April 2, 1973

Re Indian Point Unit No. 3  
AEC Docket No. 50-286

The purpose of Attachment A is to summarize the modifications that are being incorporated into the electrical design in response to your letter including the proposed modification for Item 4. The FSAR will be amended to update, where necessary, information affected by the modification for Item 4.

FIG. 1

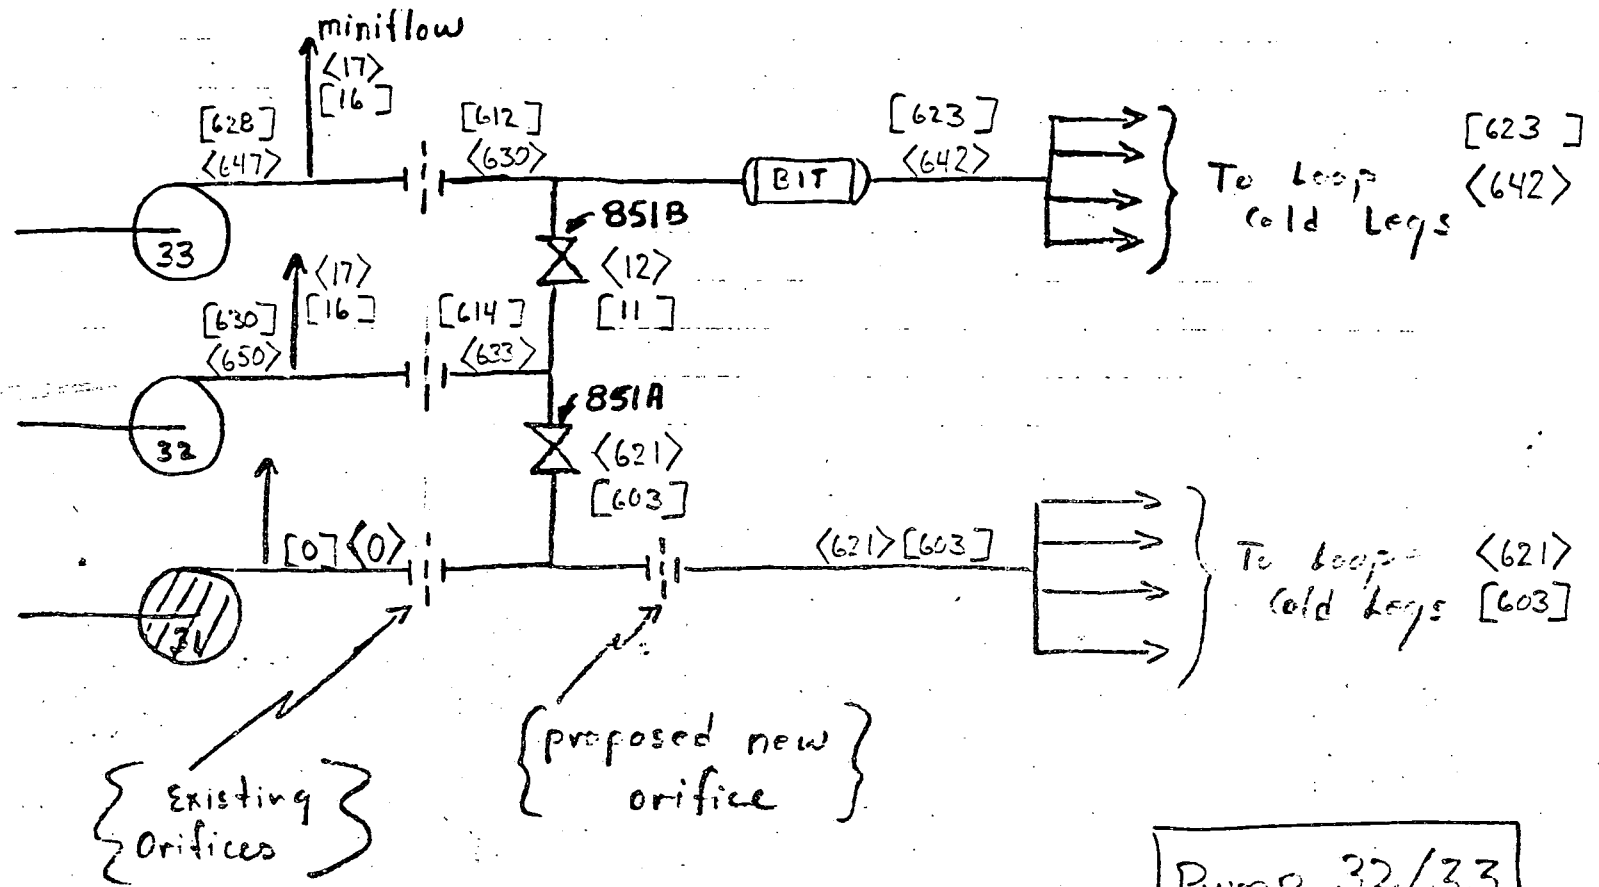
Valves 851A & B will be left open by locking the power off these valves. An orifice plate will be placed in the header from Pump 31 to ensure that sufficient flow from Pump 32 goes to header from Pump 33 (header with Boron Injection Tank, BIT). The flow requirements for this system as dictated by the Emergency Core Cooling analysis are as follows:

- a. At least 600 gpm down header with boron injection tank.
- b. At least 1200 gpm total down both headers.
- c. Pump runout flow equal to or less than approximately 670 gpm/pump (i.e., injection flow plus miniflow  $\leq 670$  gpm/pump).

Two arrangements were considered:

- (a) Pump 31/32 combination
- (b) Pump 32/33 combination

For each arrangement, two analyses were done (see Figures 1 & 2):

- (1) Using lowest of the three certified pump curves further reduced by 5% of design head.
- (2) Using highest of the three pump curves.

Analysis 1 was used to satisfy Requirements a and b.  
Analysis 2 was used to satisfy Requirement c.

Existing orifices will be modified to reduce resistance. The "new" orifice will be sized during pre-operational tests to restrict Pump 31 header flow sufficiently to ensure  $\geq 600$  gpm to Pump 33 header (through BIT). Orifices sizes have not been determined yet, but will be sized conservatively with  $CD = 1$  (i.e, hole will be too small) and true required hole size will be done in field using test data.

Figure 3

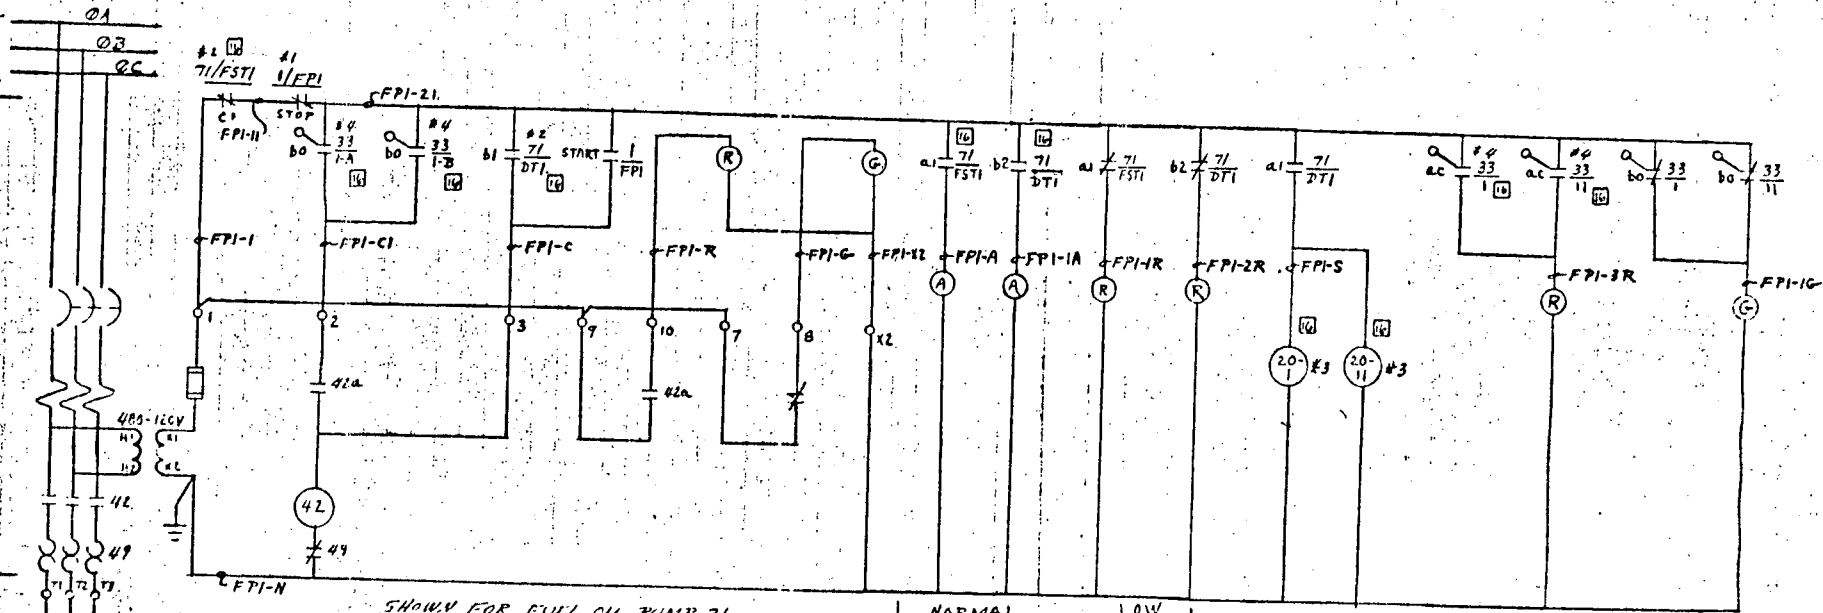
The pump sequencing switch will be removed and the fuel oil transfer system control circuits will be modified to provide functional control on a 1-pump to 1 day-tank basis (see Figure 3). There will be no change in the piping arrangement.
